PRODUCT UPDATE

AIC Version 8.5 Software Update Available

AIC Screen if Pump is Not Recognized

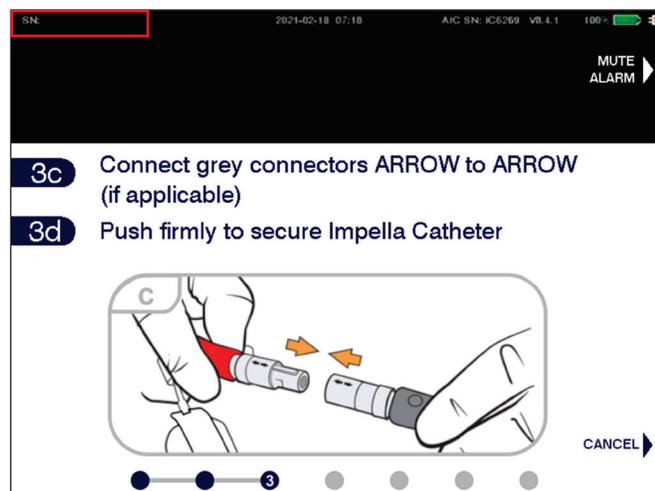
The Impella version 8.5 software for the Automated Impella Controller™ (AIC) contains bug fixes and additional data sent to Impella Connect®. This software will resolve an occasional issue seen in version 8.4 where a pump is not recognized by the AIC. While version 8.5 is being rolled out, instructions are provided on troubleshooting should this error occur.

During Case Start, if the pump is connected to the AIC but the Impella pump type and serial number are not displayed (shown in red) and the AIC continues to instruct a user to connect the pump, then this is likely an issue with the console recognizing the pump. This is a rare occurrence, however if it does happen this is not an issue with the pump itself, rather the AIC software.

1. Disconnect the pump
2. Reboot the AIC
3. Reconnect the pump and push firmly to ensure complete connection, continue Case Start
4. If the pump is still not recognized, switch to backup controller*
5. If a backup controller is not available, call Field Service to discuss getting a loaner sent

A fix for this issue has been released in version 8.5 software. This software will begin to be distributed through preventative maintenance and for new AIC consoles. It is recommended that all consoles are upgraded to this version of software as soon as possible.
